# DEVELOPMENT REVIEW BOARD PANEL A AGENDA

April 10, 2023 at 6:30 PM

2. [Resolution No. 413. Precision Countertops Project. The applicant is requesting approval of a Stage 1 Preliminary Plan, Stage 2 Final Plan, Site Design Review, Waiver, Class 3 Sign Permit, and Type C Tree Removal Plan for development of a 66,000 square foot corporate headquarters and fabrication facility on property located at 25540 SW Garden Acres Road.](#)

Exhibit A1  
Staff Report  
Wilsonville Planning Division  
Precision Countertops  
Development Review Board Panel 'A'  
Quasi-Judicial Public Hearing

**2 FIRE SERVICE SITE PLAN**  
1" = 20'-0"

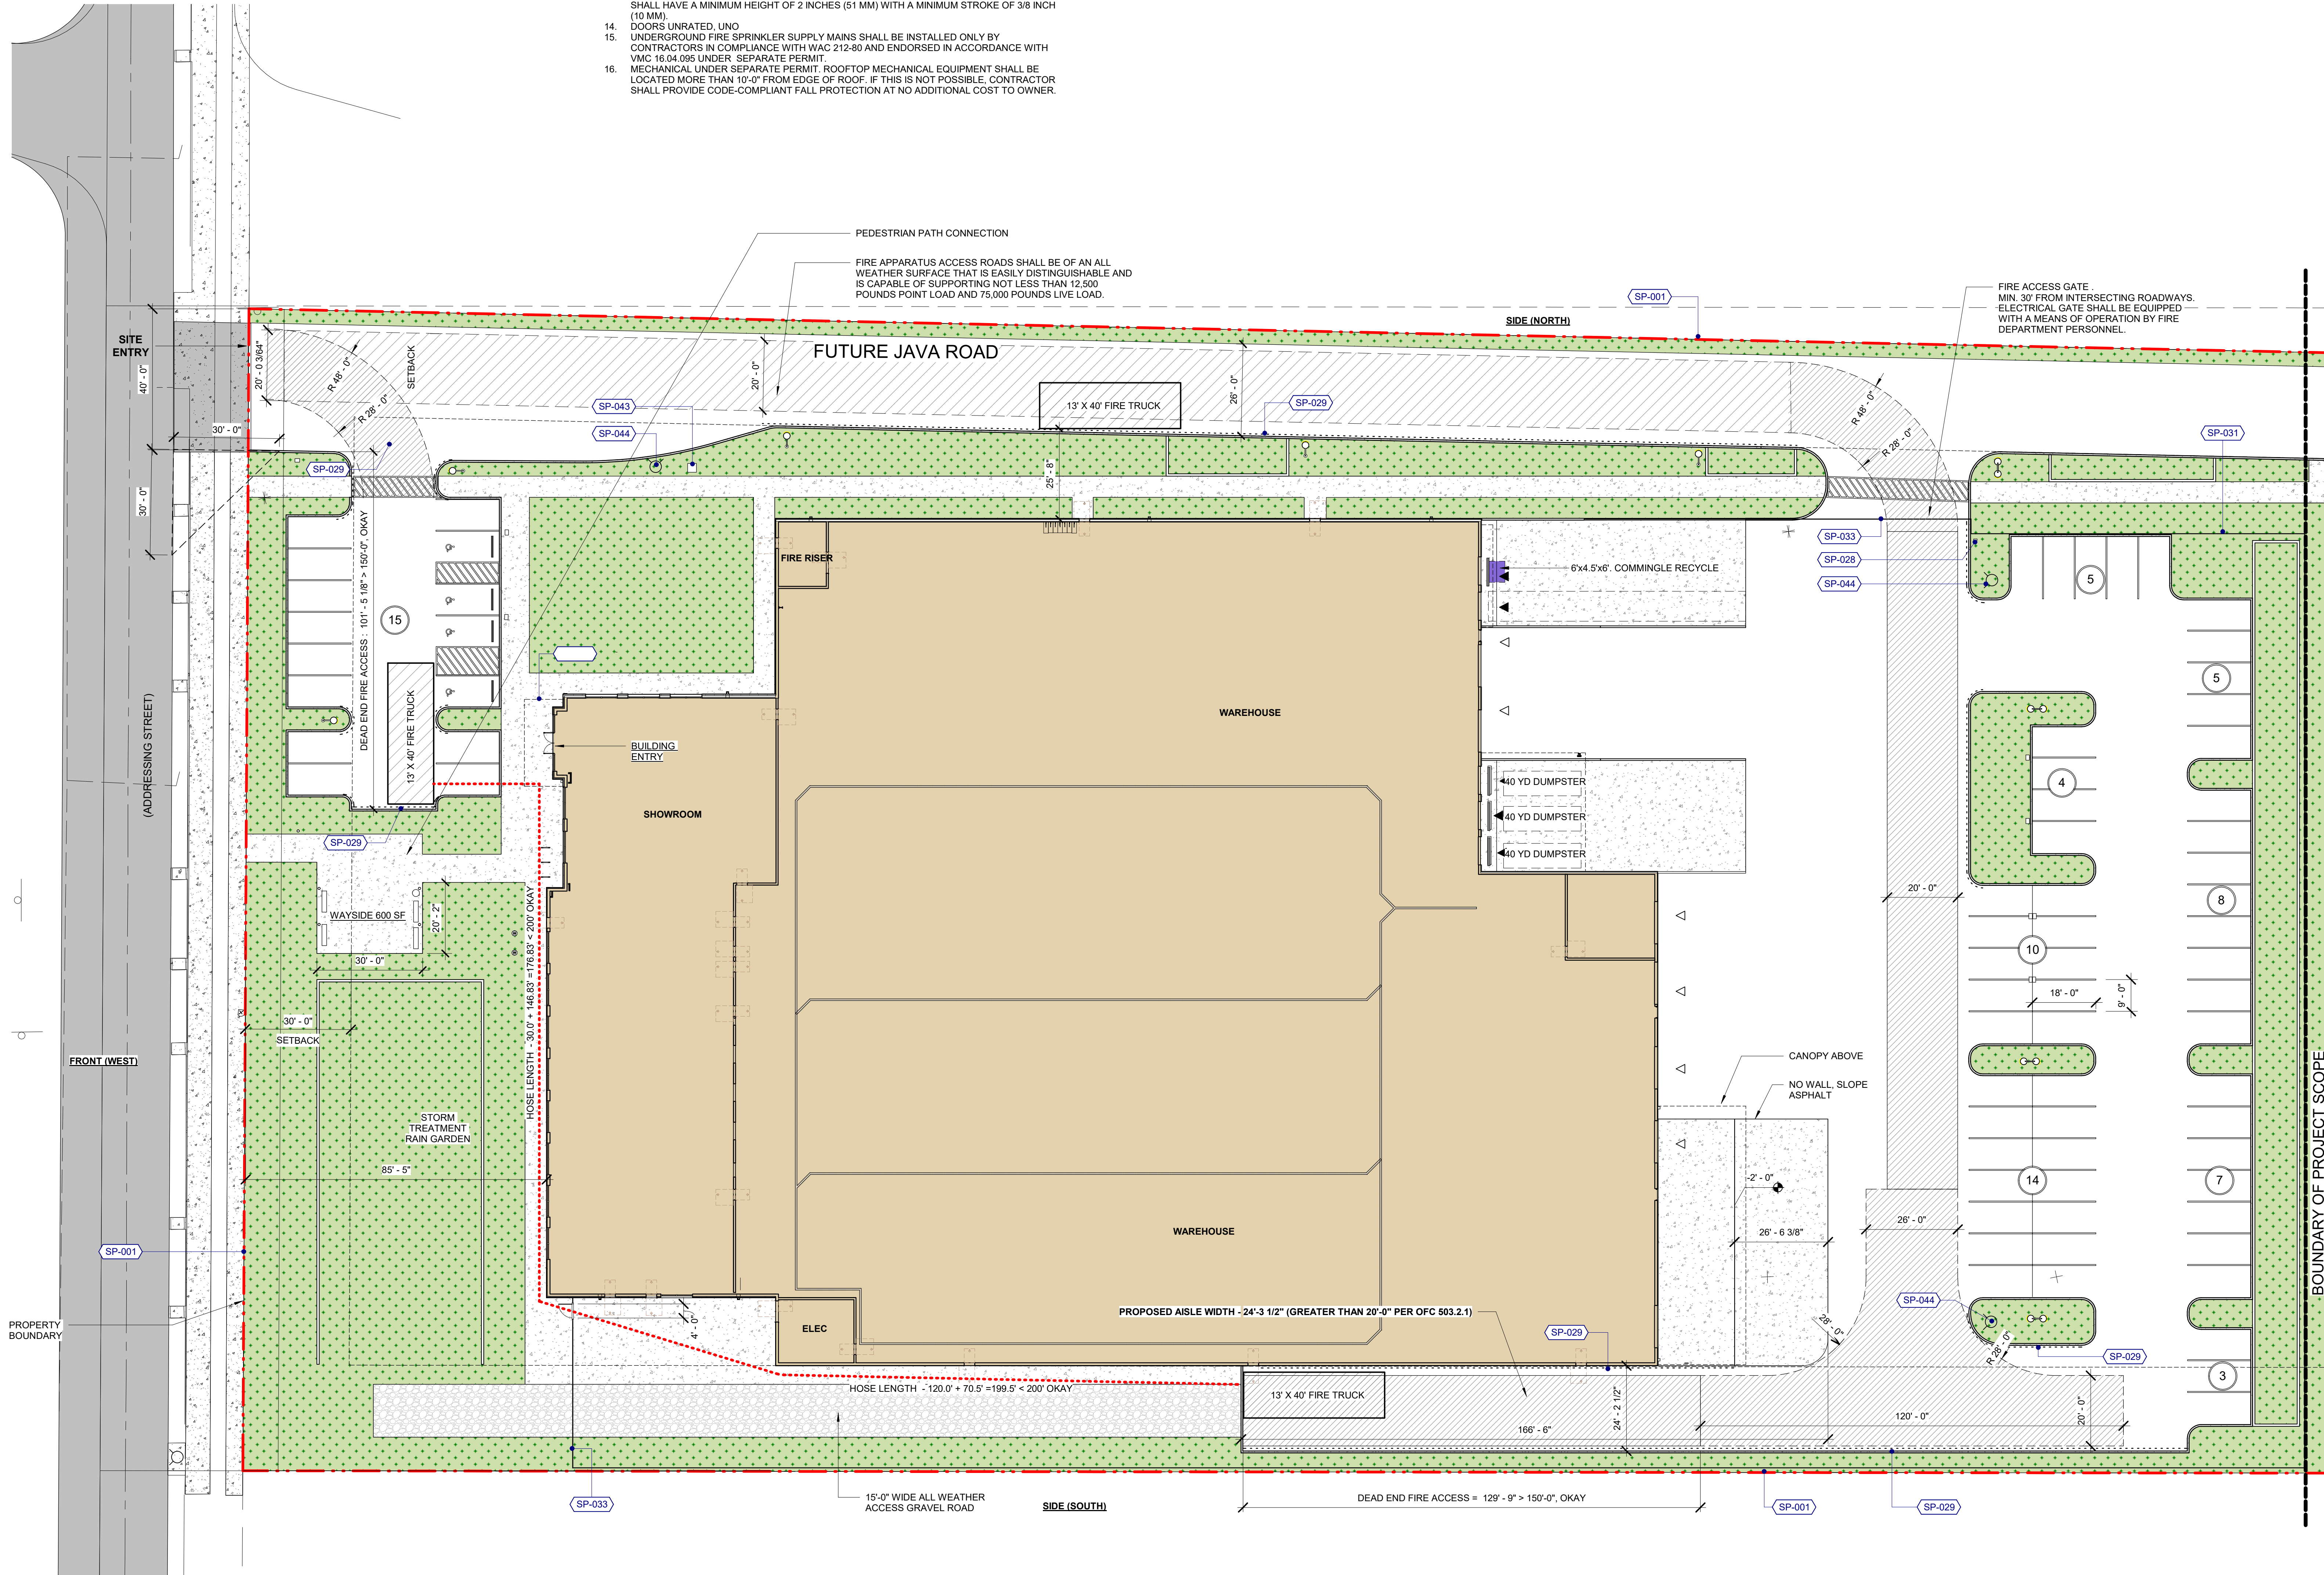
- C. *It would facilitate staff's review to separate the site plan from the fire service plan, which are combined on sheet A1.0 in the plan set. Engineering and Natural Resources Comments (in addition to incomplete items included above)*

**Response:** Please reference sheet FS1.0 Fire Service Site Plan illustrating pedestrian path connections, fire apparatus access, gate access, hydrant locations, driveway and aisle width, etc.

**1 BUILDING SIGNAGE DETAIL**  
1/2" = 1'-0"

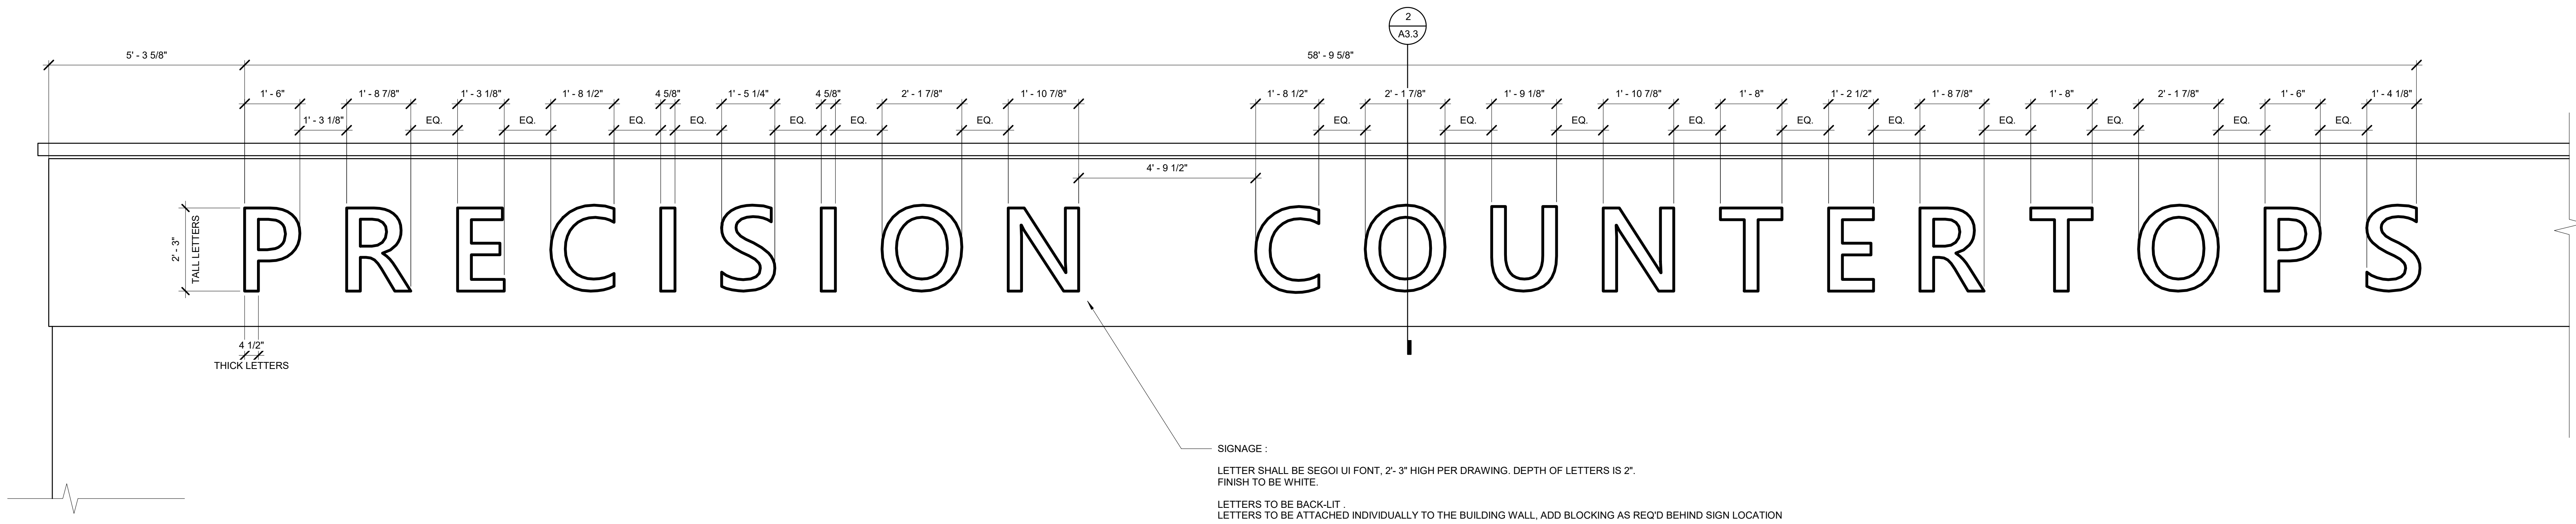
E9. The sign measurements use individual elements, as allowed by this subsection. However, the calculations of sign area shown on the applicant’s sign plan Sheet A3.3 in Exhibit B2 are incorrect. The standard requires that a sign constructed of individual elements such as letters, figures, etc., attached to a building wall be measured using the summed area of up to three squares, rectangles, circles, or triangles drawn around all sign elements. The applicant has measured the area of each individual letter rather than using three or fewer rectangles drawn around the letters or words in the sign. A condition of approval ensures that the sign will be measured correctly and adjusted as needed to comply with the standard as the time of application for sign approval.
